ZANCOR HOMES

OLDE WINCHESTER
BROOKLIN, ONT

SITE GRADING PLAN

LOT NUMBER
129

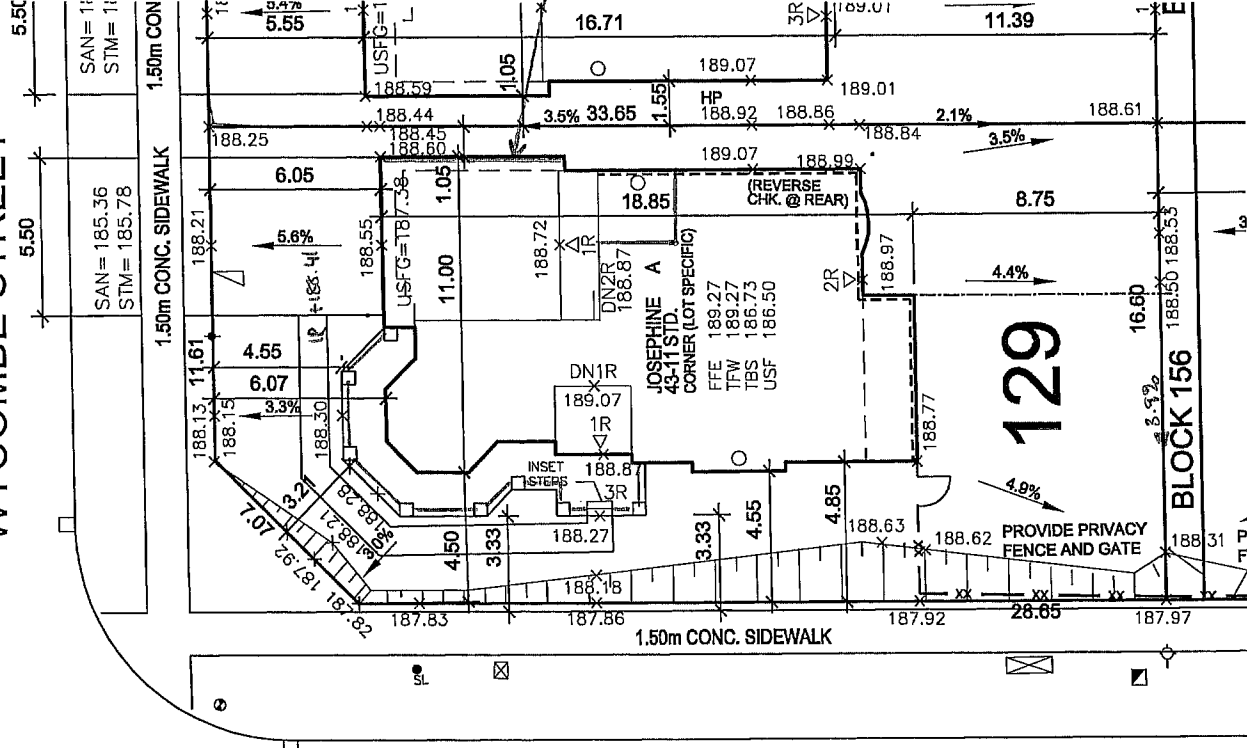
LOT GRADING PLANS APPROVED
SUBJECT TO REVISIONS NOTED
